**UNIFIED INTERPRETATION OF PROVISIONS OF IMO SAFETY, SECURITY, AND
ENVIRONMENT-RELATED CONVENTIONS**

**Draft unified interpretations on the details of duct penetrations
(SOLAS regulation II-2/9.7)**

Submitted by IACS

Figure 1 - Length of the steel sleeve

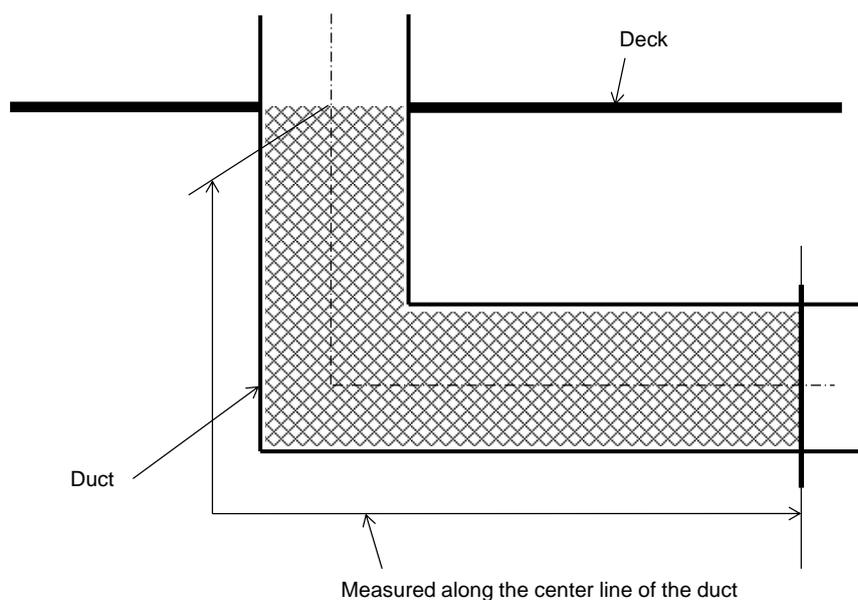
In the case of a duct that passes through, and then curves under a deck, the length of its steel sleeve should be determined according to the centerline of the duct as shown in figure 1 below.
